Natural Resources Wales permitting decisions

Determination of application to vary environmental permit EPR/ZP3933NJ, Operated by The Treatment Hub Limited.

Application for a Bespoke Permit Variation

Refusal

Figure 6 – Segregation of Hydrocarbon Contaminated Wastes

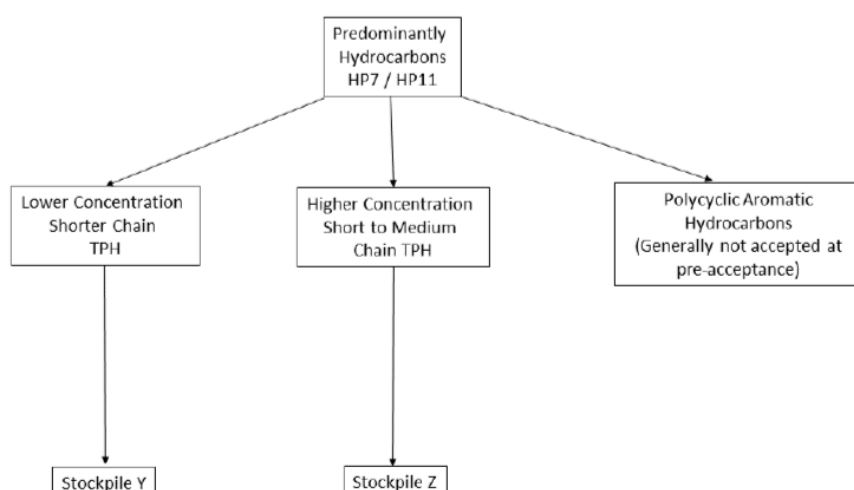
The site plan in figure 3 does not match with the stockpiles shown on the flow diagrams in figures 5 and 6.

Figure 3 – Illustration Showing Proposed Stockpile Arrangement

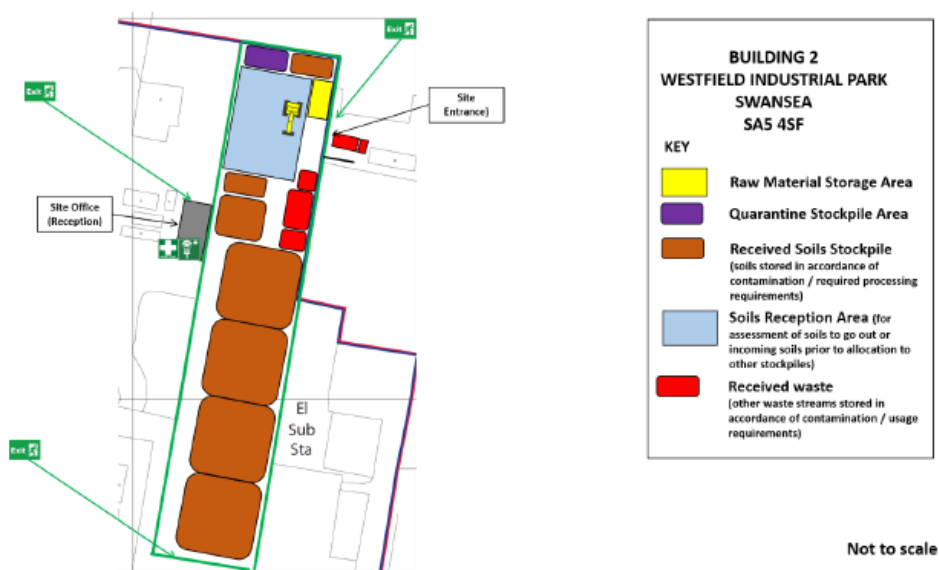
Criteria for establishing the degree of compatibility and criteria for establishing if the compatibility is sufficient to permit them to be combined for storage and treatment is not given

The wastes would be stockpiled together, not just from different sources and with different levels of contaminants but they also include wastes at different stages of processing combined within the stockpiles. The application does not explain how the treatment process will be managed to treat different parts of the stockpiles in different ways when they are co-located in the same stockpile. In addition the application does not detail comprehensive monitoring and sampling and analysis of each of the different elements of the stockpiles or describe how wastes can be separated, if needed, following testing if some required further or different treatment.

No clear description of how the process will be controlled, or details of how the end result for the many different parts of the same stockpile will be determined and how different parts will be re-separated if they continue to have different properties and concentrations of contaminants, while being at different stages of treatment (as the application gives no explanation of the stockpiles being comprehensively and thoroughly mixed).

This proposed process with its lack of controls and standards is not acceptable and this element is refused.

Figure 7 – Pre-Acceptance / Acceptance / Assessment of Soils Classified as Mirror Hazardous by the Waste Producer

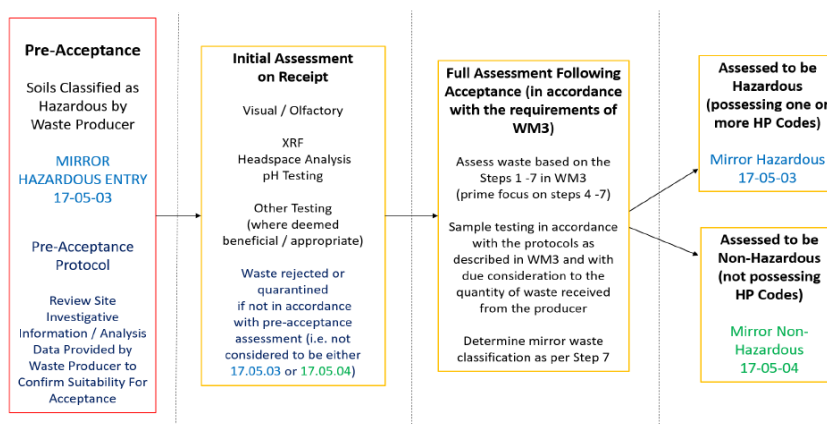
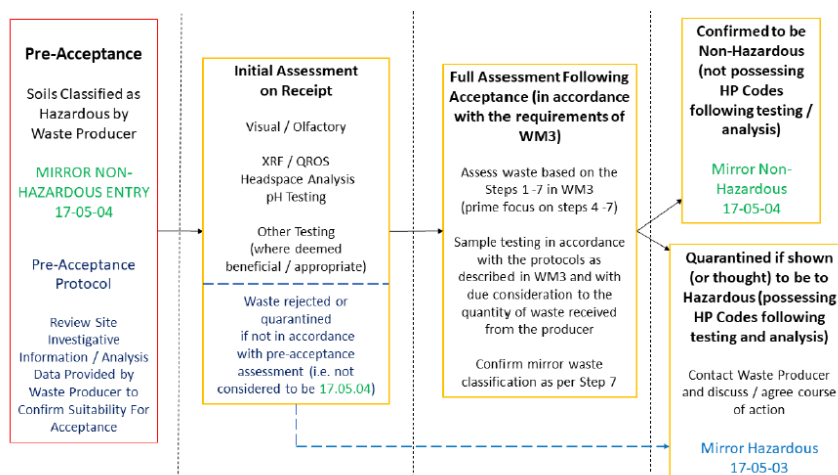
The statement that “the majority of waste soils excavated from the designated location are inherently mirror non-hazardous when reassessed” is concerning. It is concerning that waste producers are consistently making mistakes which the operator is not identifying during pre-acceptance. The applicant has made it clear that a significant proportion of the received waste arrives from sites that produce a large number of repeat lorry loads, it is therefore a surprise that miss-descriptions are not identified earlier and corrected as part of the confirmatory testing.

This again illustrates the need for the site to have adequate procedures to ensure that waste received is as described and does not need to be re-classified.

If instead, the incoming waste loads contain a mixture of both hazardous and non-hazardous waste, this would be a load of mixed hazardous and non-hazardous waste. Therefore it would be best described as 19 02 04 premixed wastes composed of at least one hazardous waste. This can be the case when contaminated soils are removed from a development site as in order to capture all of the hazardous waste, the excavations cut beyond the boundaries of the hazardous waste soils into the less contaminated soil immediately adjacent simply because it is not possible for them to precisely delineate the exact boundary of the hazardous soil. Indeed the extract from the application supporting document above talks about mixing during excavation, loading into lorries and transport.

The application proposes taking an unspecified number of samples from unspecified quantities of waste soils and then simply re-classifying the soils, this has not been sufficiently justified.

This procedure, described as taking place for the majority of the waste, is not recognised as being an appropriate operating technique.

Figure 9 shows

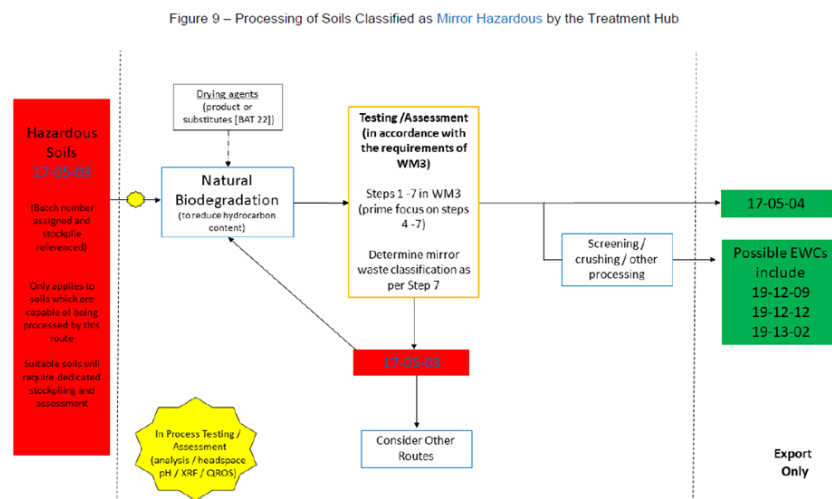
Whilst the application refers to the process as “natural” biodegradation, we are talking about treating wastes so heavily contaminated with hydrocarbons that they are classified as hazardous waste. The application does not provide an explanation as to how the process will take place and be controlled. The process description makes no mention of biological agents, but it is assumed that these are the basis of this proposed process.

It does not say how the process will be managed effectively when it has already described the “heterogenous” nature of the wastes and the proposal to co-stockpile and treat different wastes together. This will inevitably mean co-treating wastes containing different hydrocarbon contaminant loadings and at different stages in treatment (as the storage and treatment stockpiles appear to be one and the same as discussed previously).

The application makes no mention of process controls necessary to manage the operation such as controlling temperature or mixing or turning the waste to regulate aeration, no mention of introduction of air on control of aeration, no mention of mixing of bacteria (if bacteria are indeed a part of the process). No control of rate or ratio of addition of additives to aid the degradation process.

appear to disappear, presumably into the air. We anticipate that the proposal will result in emissions (CO₂ and volatile hydrocarbons as a minimum), however the applicant has not supplied sufficient information for them to be quantified and for any potential impacts to be assessed.

The process seems instead to rely on leaving the waste in a pile and re-testing hydrocarbon content from time to time. There isn't a clear regime for sampling from these proposed large combined stockpiles to ensure that all materials meet the standard rather than just the location of potentially very limited number of samples (or even just a single sample). No details of assessment of other potential contaminants (it does not necessarily follow that hydrocarbons will be the only contaminant present in these waste streams).

The flow chart included in the application as figure 9 (shown above in section 5) shows a potential route where other wastes may be added as a drying agent and natural biodegradation taking place. It then shows the output being classified as 17 05 04 (see comments in section 5 which reviewed the biodegradation). Alternatively it shows further processing via screening, crushing or other processing to produce the following waste streams

These above descriptions are inconsistent with the described starting point as a waste soil containing hazardous substances as these post mixing descriptions are all wastes that do not contain hazardous substances. The details provided by the applicant show no separation of hazardous fractions from within the waste, hence it must still be present.

The application for this process so far as it has been made is refused on the basis of insufficient information on the process, the process controls, the emissions and emission controls.

Figure 10 shows

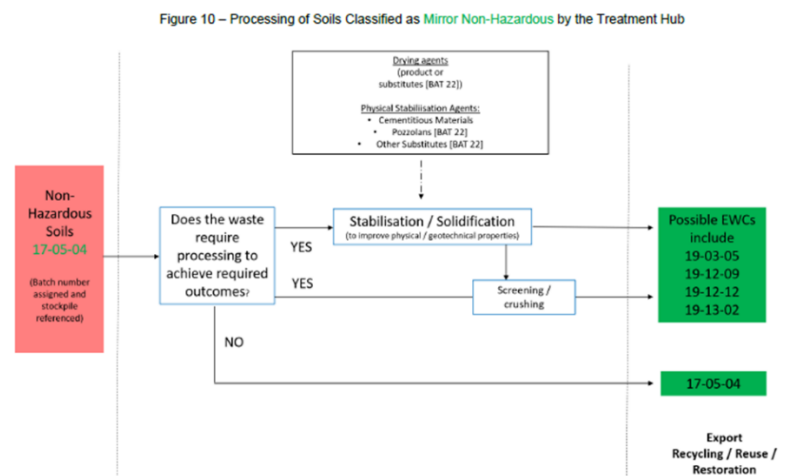
The flow chart included in the application as figure 10 on page 29 shows that wastes may be added for drying or stabilisation. It then shows the output being classified as

For some of the listed wastes used as treatment materials it may be theoretically possible to produce 19 03 05 (such as by using non-hazardous wastes). However the list of wastes used as treatment substitutes includes some hazardous wastes. The applicant has not justified how the use of these hazardous wastes would be mixed with non-hazardous soils to produce the non-hazardous output. In addition process controls on quantities of these wastes to be added have not been provided.

As the list of proposed wastes includes several wastes that are hazardous in their own right then this proposal will in many cases cause the classification of the material to move from non-hazardous to hazardous. This is an unsatisfactory proposal.

As with proposed outcome 19 03 05 above, it may be theoretically possible to produce a material that would meet this code. However the process is not described in sufficient detail and the absence of process controls or detailed and comprehensive monitoring means that we cannot fully assess if the applicant will be able to achieve this in those theoretical situations. However for the other situations, such as when hazardous wastes are mixed with the non-hazardous soils, then this description would not be appropriate.

This aspect of the application is refused.

Figure 11 shows

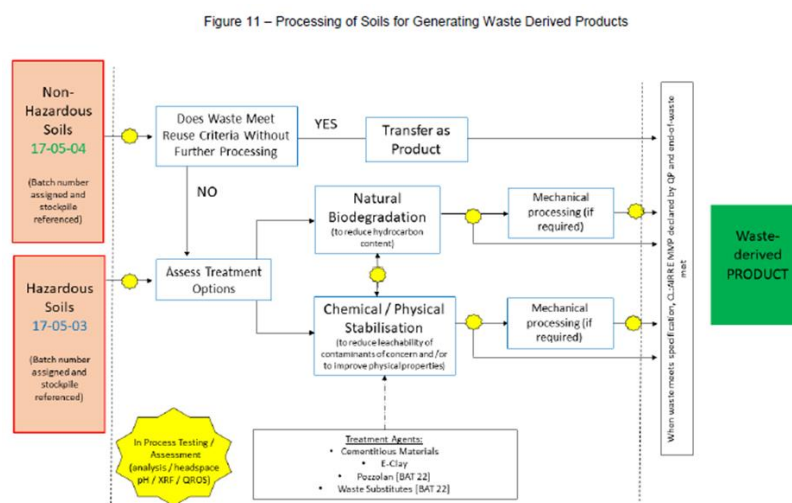
The flow chart in figure 11 (below) also shows non-hazardous soils undergoing the biodegradation process.

For proposed “product” without any treatment this would appear to be inappropriate, as it remains untreated and is simply the waste as was imported and not a product (as shown on top line of flow diagram figure 11).

The flow chart in figure 11 also shows a possible pathway for non-hazardous soil to have wastes added, the purpose is described differently from table 10 (discussed above), this time the stated purpose is chemical or physical stabilisation. This flow chart gives the output as a “waste derived Product”.

The applicant has not provided technical detail as to how the addition of other “treatment” wastes will be controlled. With the list including wastes so contaminated that they themselves are classified as hazardous, the necessary controls need to be comprehensive. The pathway to create waste derived product or some of the proposed re-categorisations of the waste listed above are not adequately justified.

The flow chart in figure 11 shows wastes added for the purposes of chemical or physical stabilisation, with the new combined waste going on to become a “Waste derived Product”.
